300 Studebaker Road Industrial Park Project

Final Initial Study – Mitigated Negative Declaration

1 Responses to Comments on the IS-MND

FIGURE 7

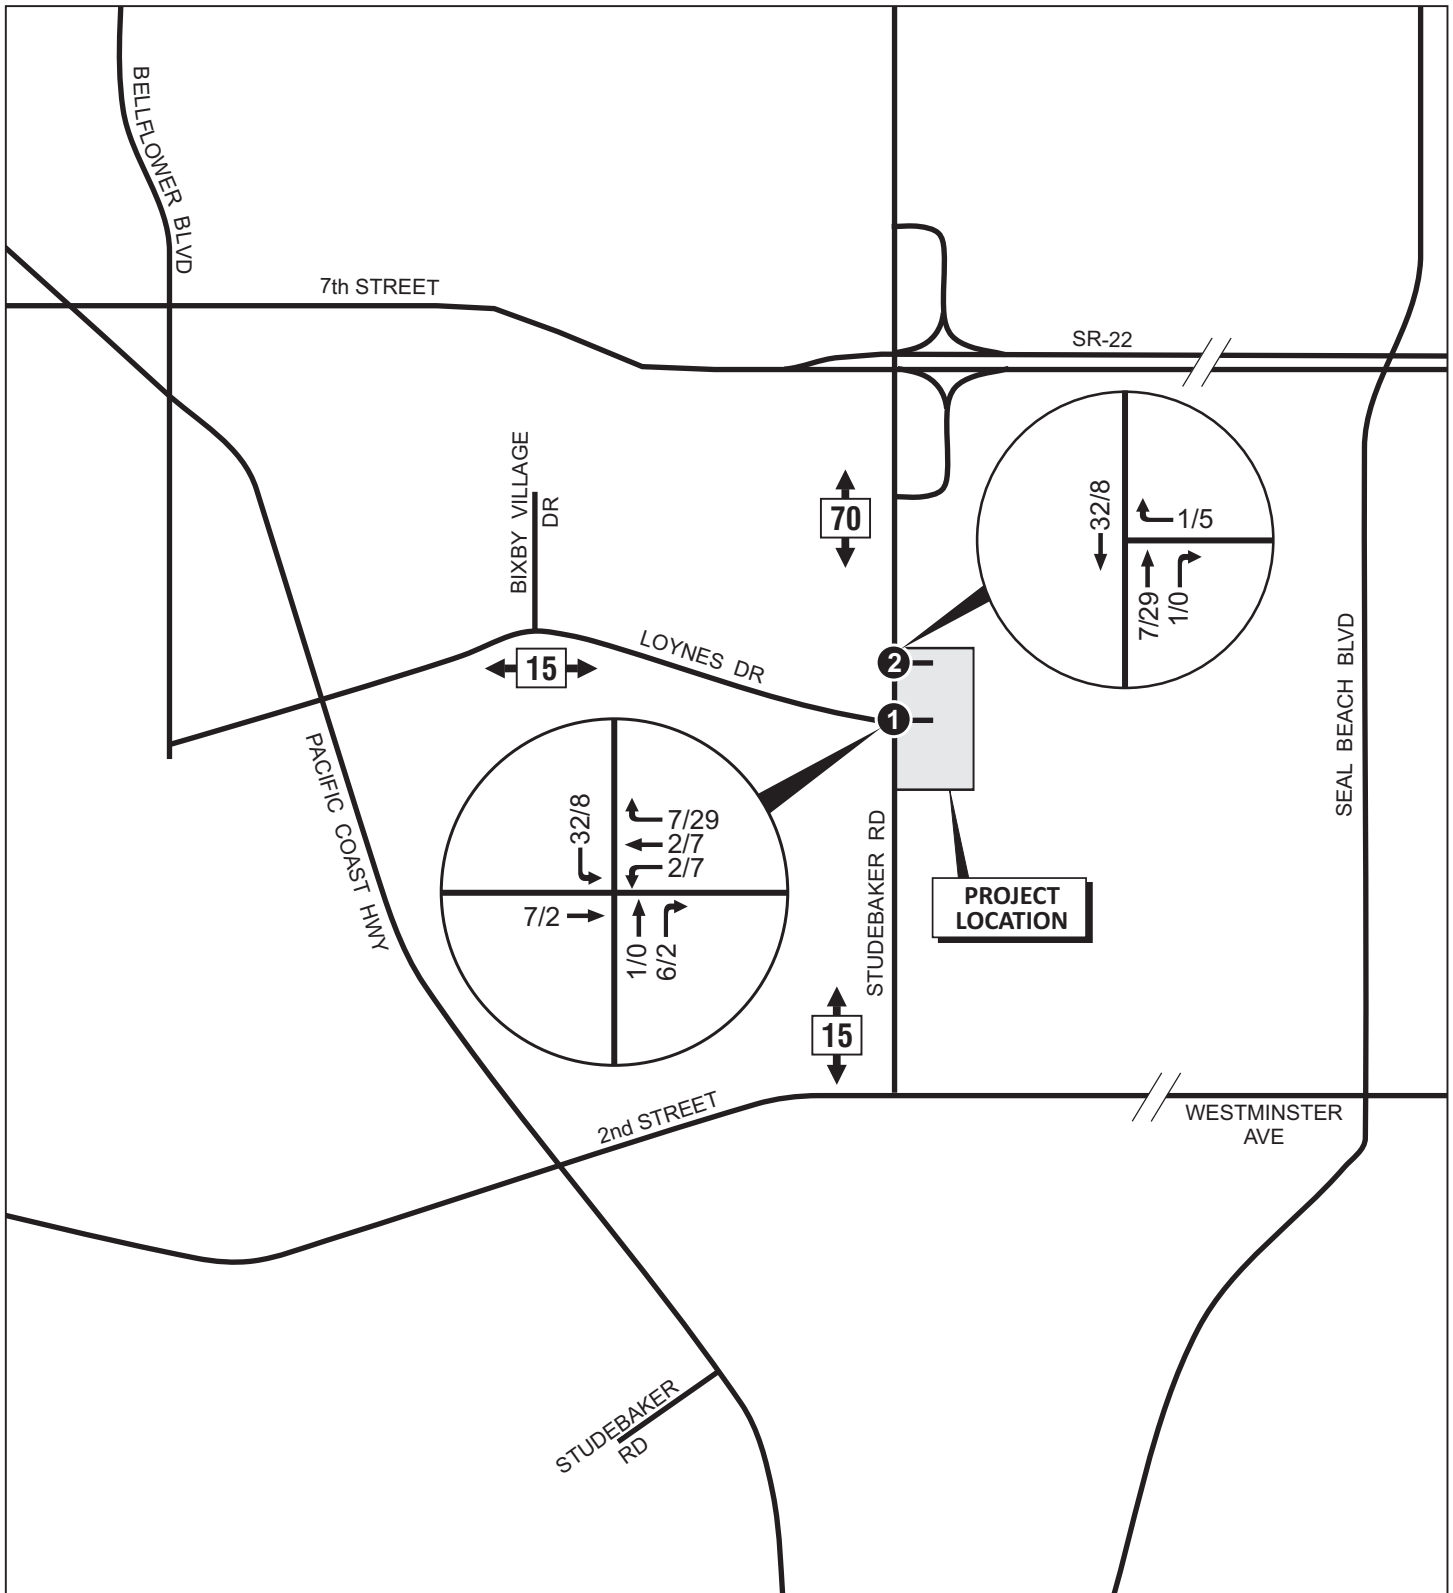
1. Generates over 100 peak hour trips assigned to a State highway facility
Per Figure 7 of the TIA, the project would generate a maximum of 34 p.m. peak hour trips towards any State Highway Facility (Pacific Coast Highway or SR-22). This is below the 100 peak hour trip threshold.

2. Generates 50 to 100 peak hour trips assigned to a State highway facility – and, affected State highway facilities are experiencing noticeable delay; approaching unstable traffic flow conditions (LOS “C” or “D”).
Per Figure 7 of the TIA, the project would generate a maximum of 34 p.m. peak hour trips towards any State Highway Facility (Pacific Coast Highway or State Route 22). This is below the 50-100 peak hour trip threshold.

Figure 7 of the TIA illustrates the project trip assignment. Based on the trip distribution of the project trips (including both passenger vehicles and trucks), only a portion of project traffic would use Pacific Coast Highway or SR-22. During the p.m. peak hour, 34 trips (PCEs) would be expected to travel north of the project site on Studebaker Road towards SR-22. Along Loynes Drive, headed westbound, there is expected to be seven project trips during the p.m. peak hour, as trucks are not allowed to travel on Loynes Drive.
